# STAFF REPORT TO THE BOARD OF ARCHITECTURAL REVIEW PREPARED SEPTEMBER 18, 2012

HEARING DATE:	September 27, 2012	
FILE NUMBER:	L12-019 – McMicken Court	
APPLICANT:	Ian Hamad, Developer and Owner	
REQUEST:	Design Review approval for a mixed-use building consisting of nine residential units and three ground floor commercial spaces with associated grading, paved parking, landscaping, and site design.	
LOCATION:	The site is located at 42XX 164 <sup>th</sup> Street in the McMicken neighborhood. It is east of 42 <sup>nd</sup> Avenue South and bound on the south by 164 <sup>th</sup> Street. The property lies a few hundred feet to the east of an existing Safeway grocery store in the City of SeaTac. The tax parcel number is 5379800670. The site is currently a vacant lot.	
NOTIFICATION:	Notice of Application for this Type 4 permit was mailed to surrounding property owners, interested parties, affected agencies and posted on the site on July 5th, 2012. Notice of Public Hearing was also was mailed to surrounding property owners, interested parties, affected agencies, posted on the site and published in the Seattle Times on September 13, 2012.

# Attachment B: Colored Elevations

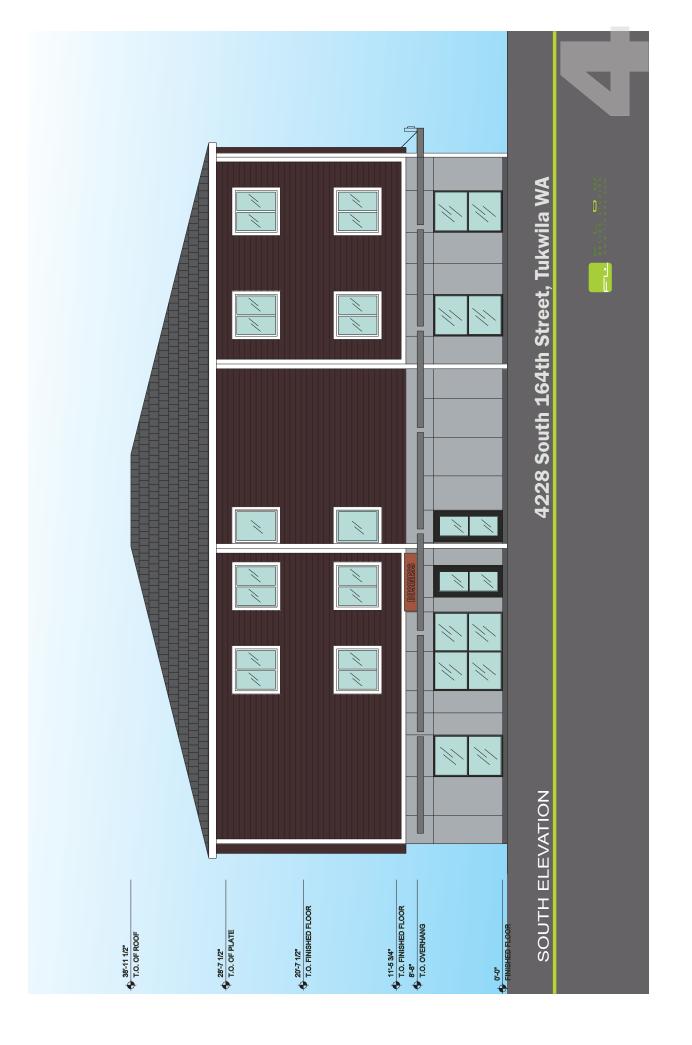
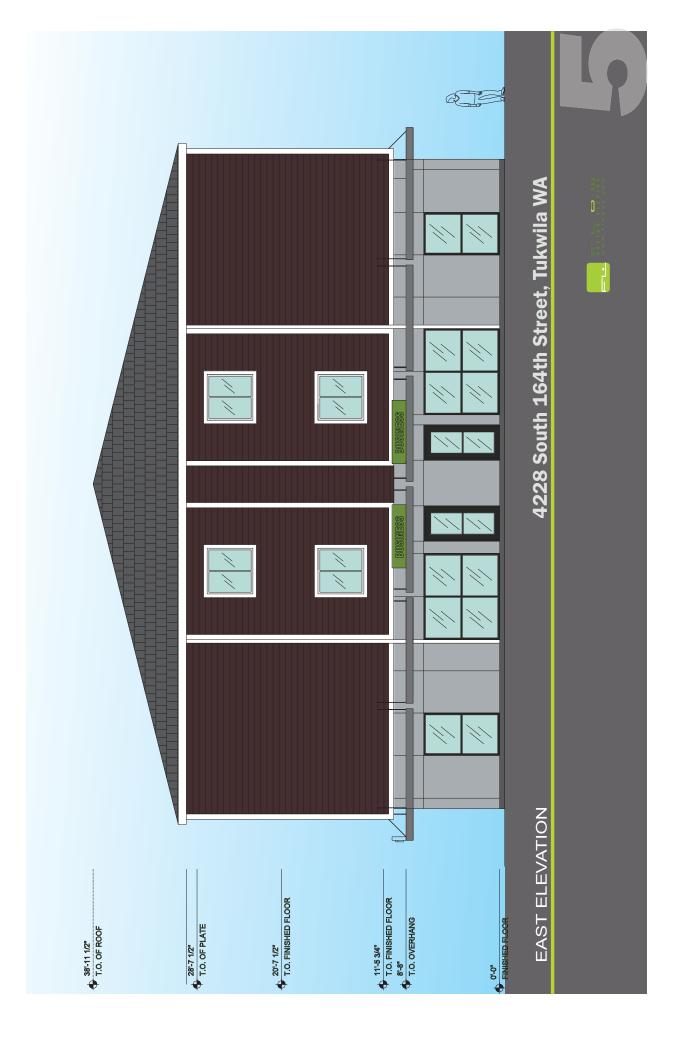
While not described on the plans, the applicant discussed and shows on Attachment B lighted sign boxes mounted to the tops of the awnings for the use of the three commercial tenants.

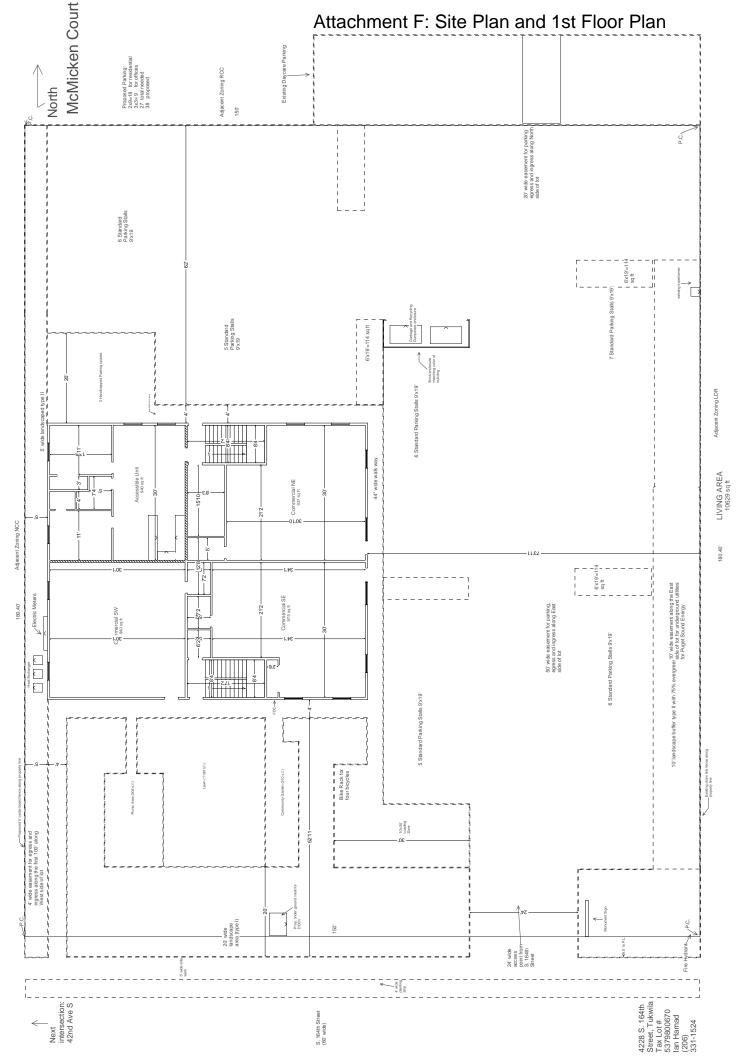
- 3. There is a playground that has proposed parking adjacent to it (marked A on landscape plan). We are concerned about the safety of children with cars parking directly against the playground with children present. A possibility would be to continue the 5 ft wide evergreen planting border in front of these cars as well as metal posts, curb running the length to prevent lunging vehicles into the playground and hitting a child. It is a huge safety issue with strangers parking in their vehicles up against a playground with clear visibility without a buffer. We also have to conform to state licensing and safety standards, and we do not a licenser to then deem it unsafe pulling our license.

- 4. We need to ensure that we have priority parking in the easement parking area (Marked A & B on the landscape plan) from 6am 6pm as stated in the easement agreement. Individual Parking stall signage stating: "Childcare parking 6 a.m 6.pm" for the easement parking would work.
